**RE: Technical Revision Request for Reclamation Plan changes at  
Carbon Valley Resource, DRMS Permit M-2001-017**

File No.: M- 2001-017 Site Name: Carbon Valley Resource  
County Weld TR# \_\_\_\_\_ (DRMS Use only)  
Permittee: L.G. Everist, Inc.

TECHNICAL REVISION - JULY 18, 2023  
MAP EXHIBIT F - RECLAMATION PLAN

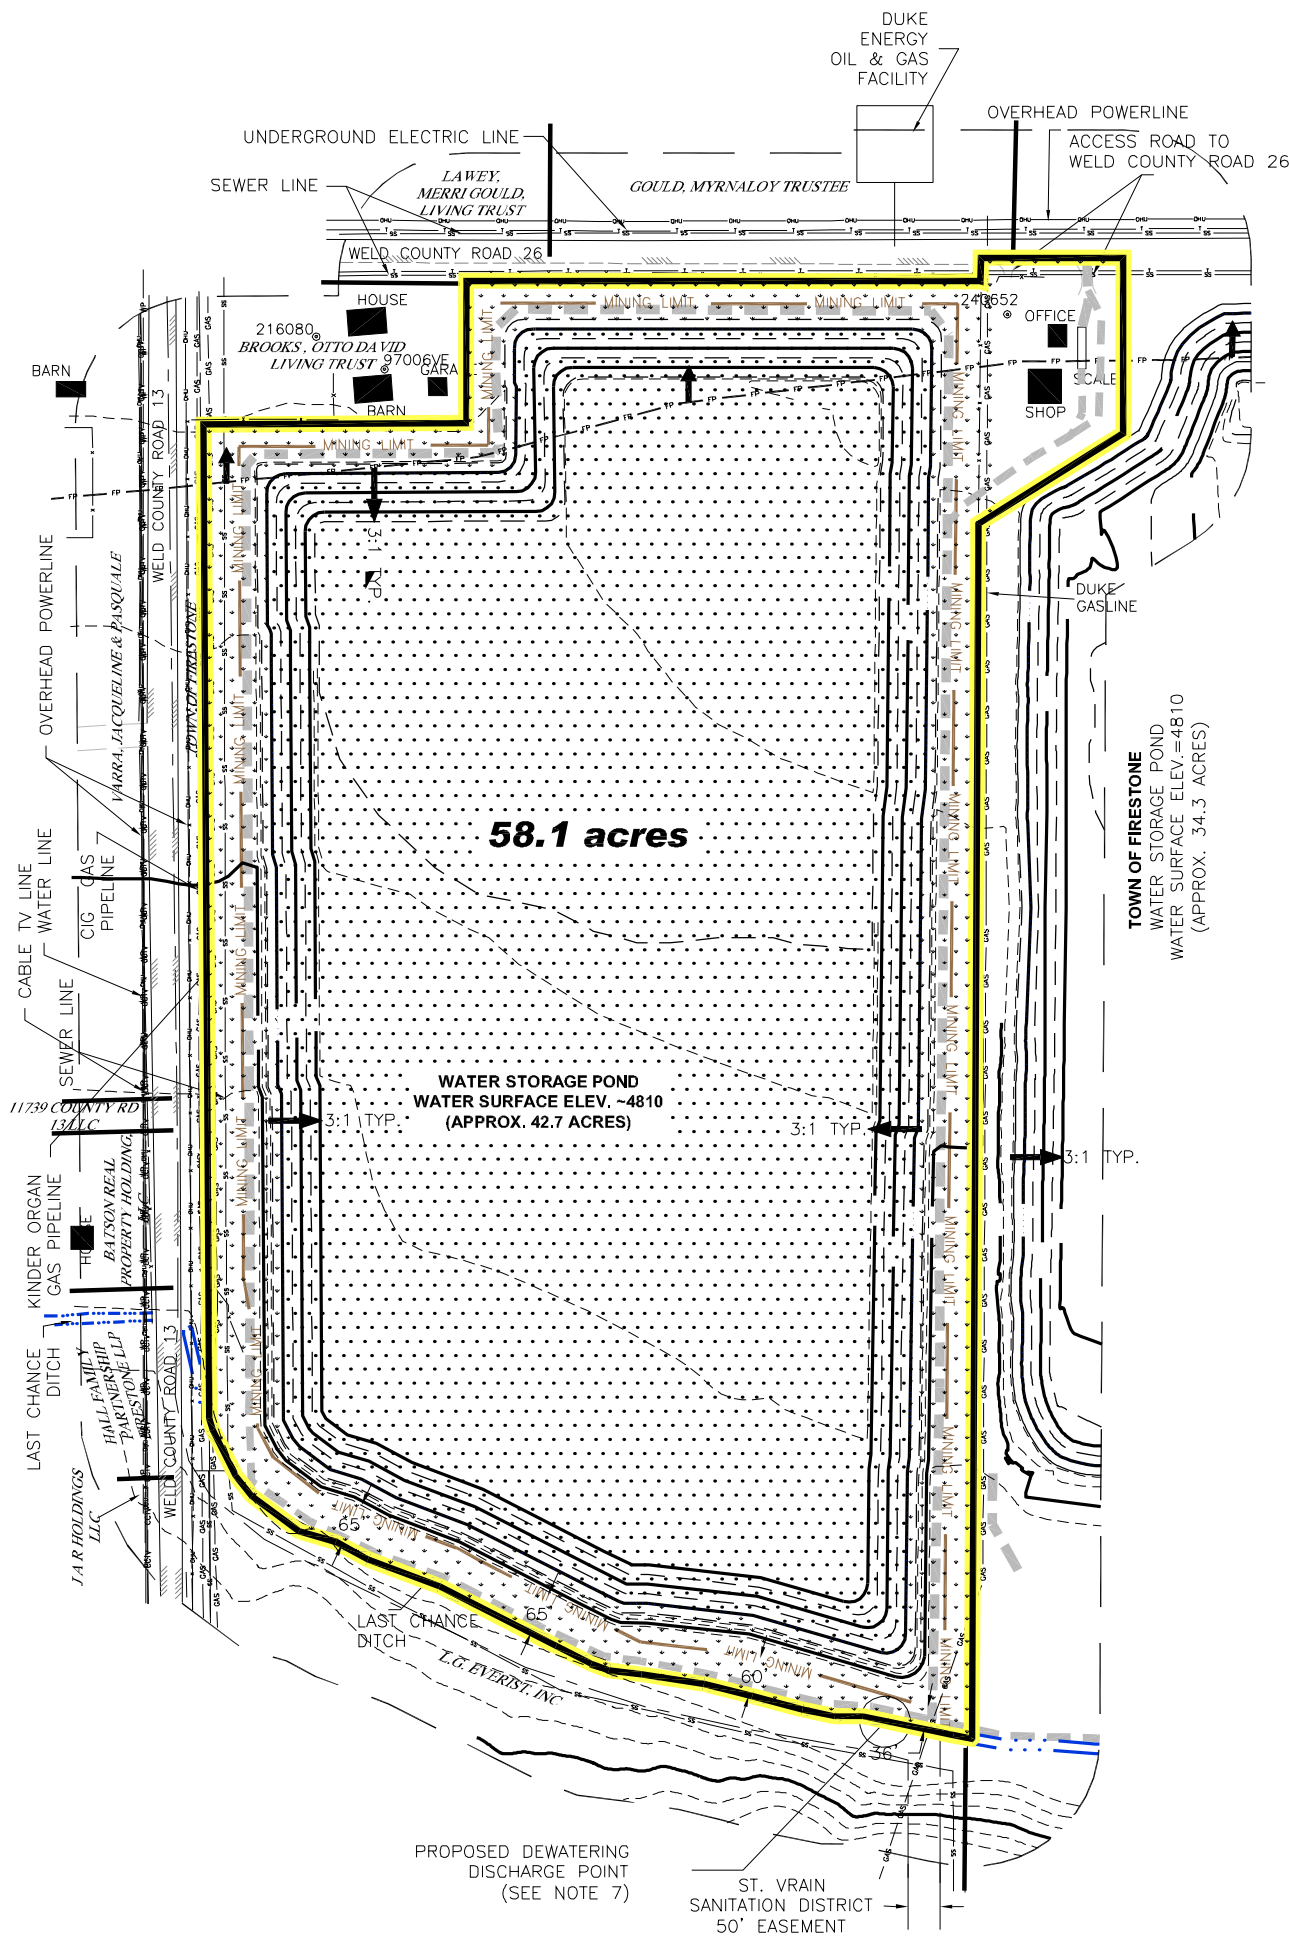
For this Technical Revision, we are slightly revising the Reclamation Plan of the Carbon Valley Resource due to the removal of oil and gas structures. (Changes to reclamation plans are always a possibility due to changes with oil and gas facilities.) Note - there are no changes to the reclamation process.

Carbon Valley Resource's reclamation plan is revised as shown on **Exhibit F - Reclamation Plan Map (April-2023)**. When PDC's wells and pipelines were operational, they were located on peninsula along the southern side of the area, and were given the required set-back from mining activity. Now, with the PDC structures and peninsula gone, the southern perimeter of the site can be reclaimed in a straighter line along the Last Chance Ditch (of course with the proper required set-backs) as shown on the map.

This is a minor revision to the reclamation plan due to the abandonment and removal of oil and gas facilities. Please see the attached cover letter, revised Exhibit F - Reclamation Plan Map, and reference files for more details.

**CARBON VALLEY RESOURCE**  
WELD COUNTY, COLORADO

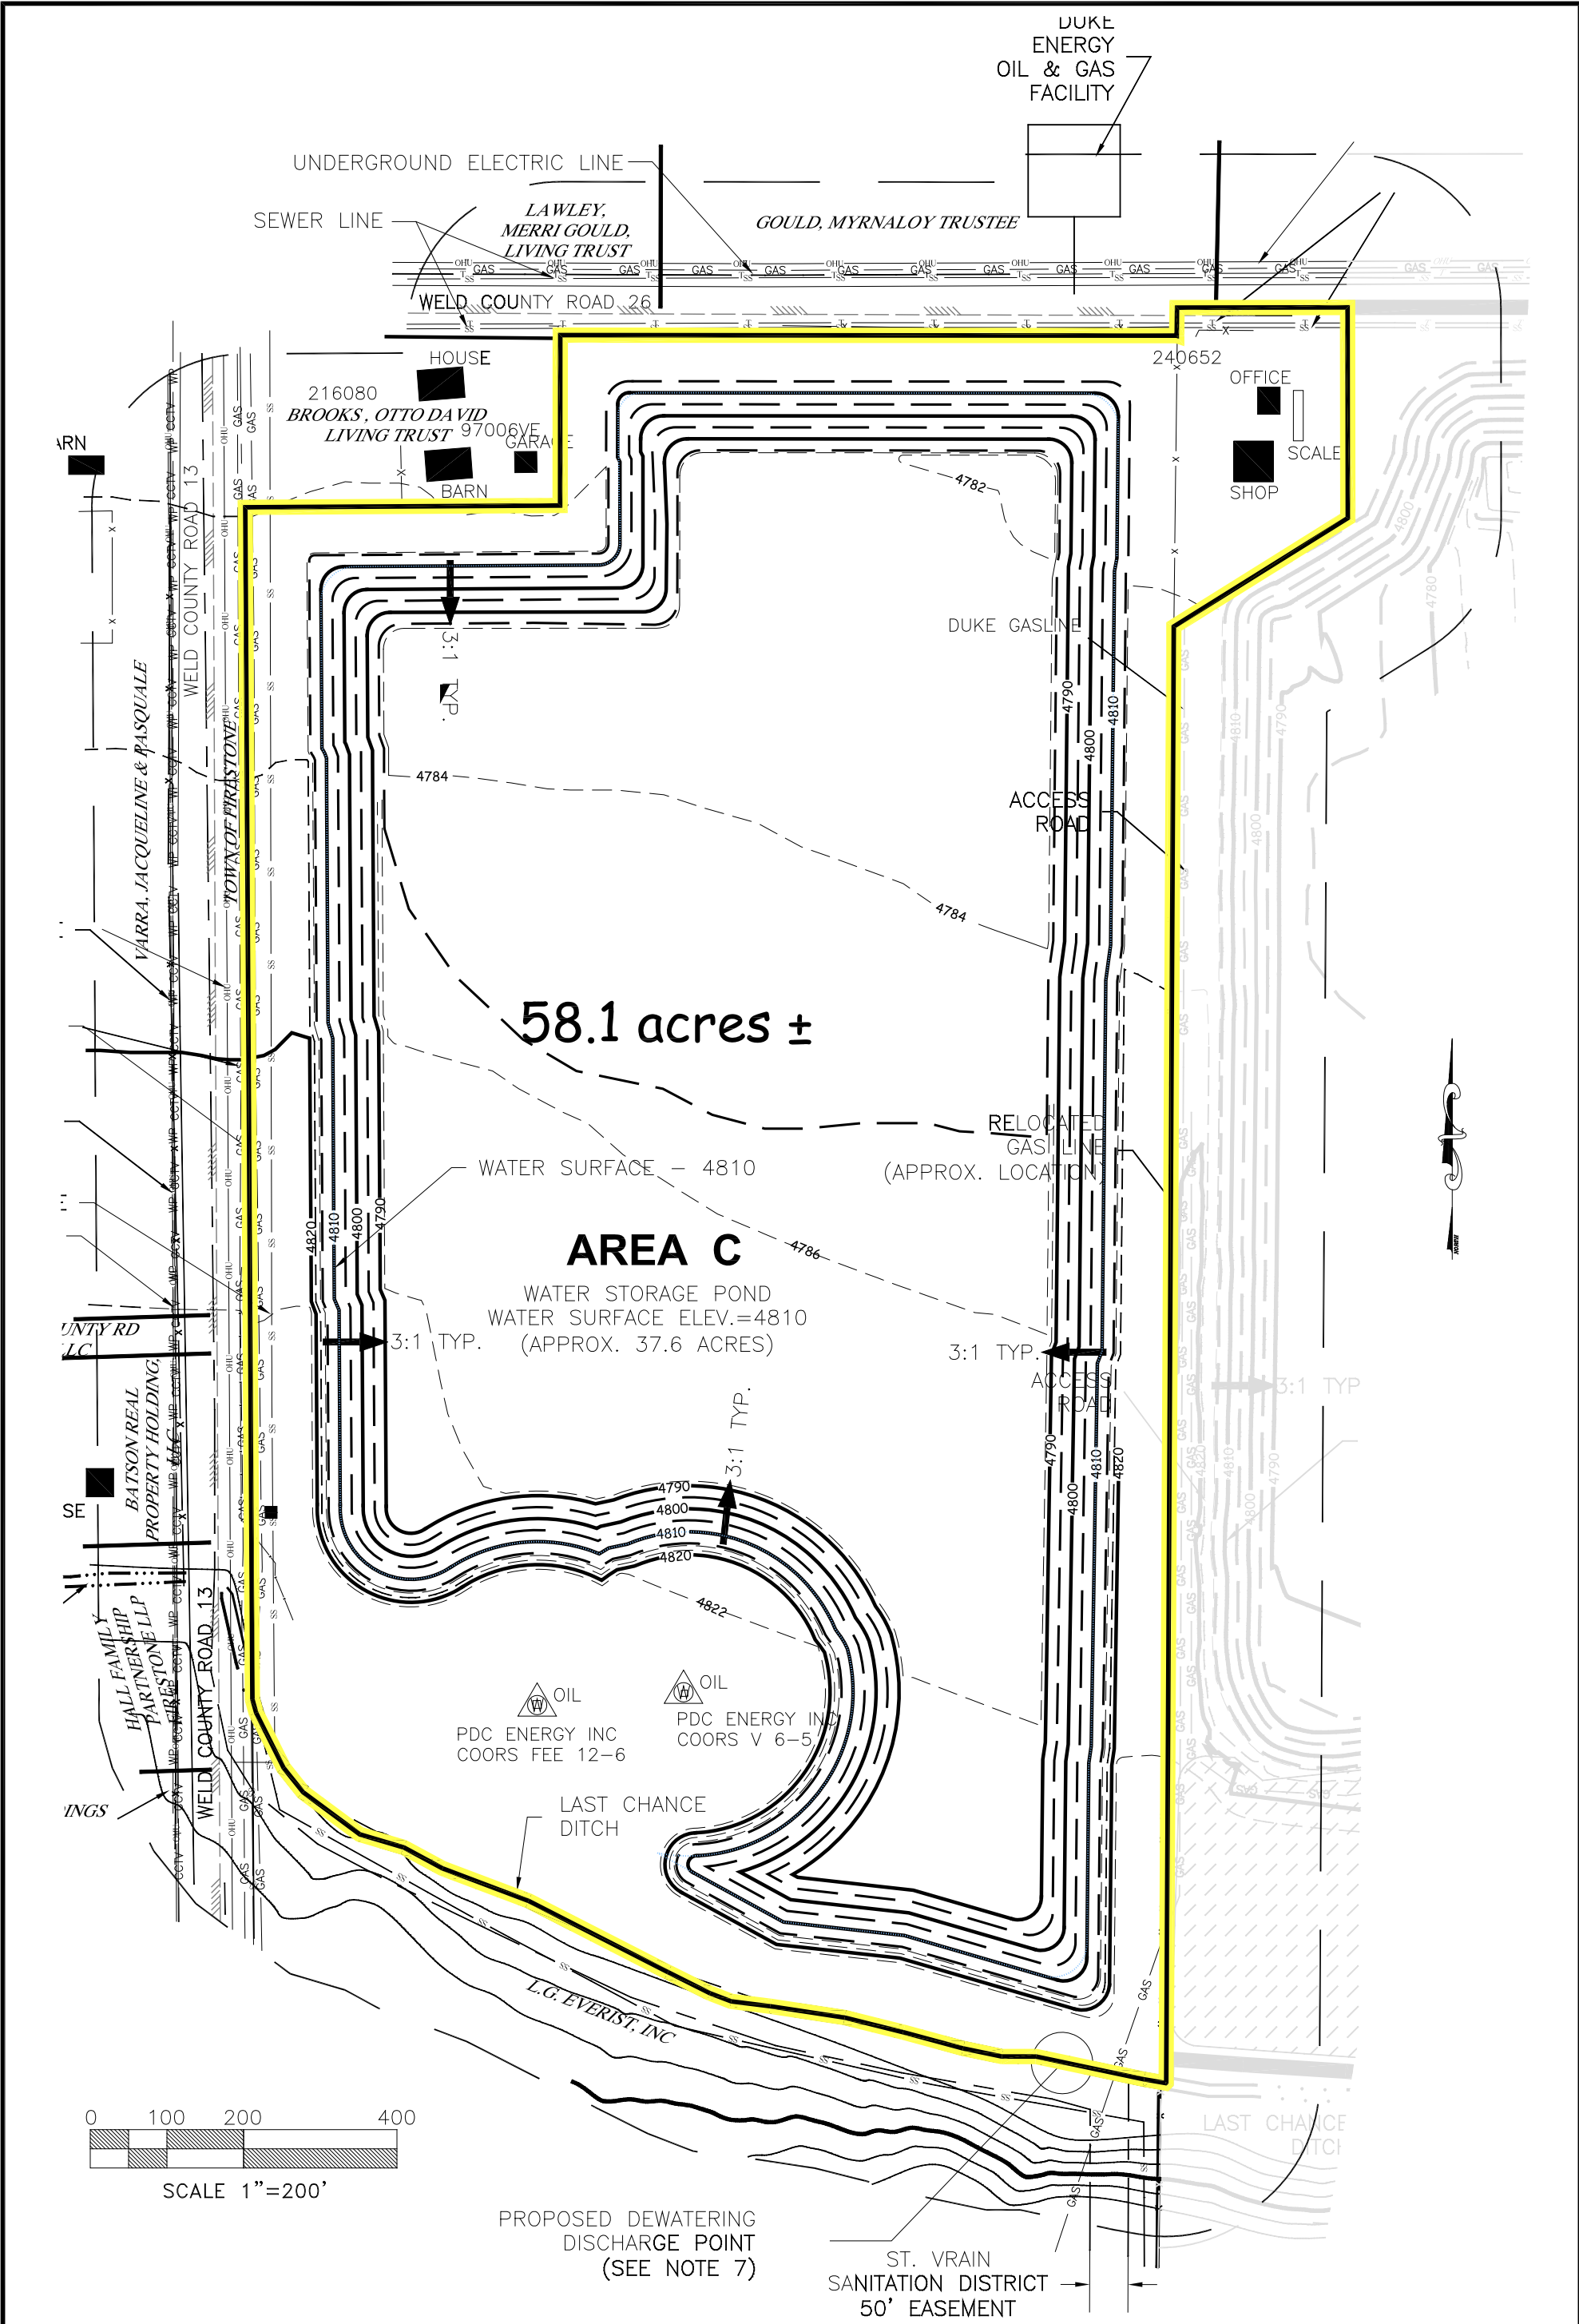
We have attached the revised (new) **Exhibit F - Reclamation Plan Map (July-2023)**, and a copy of the previous (old) **Exhibit F Reclamation Plan Map (2018)** is attached for reference.
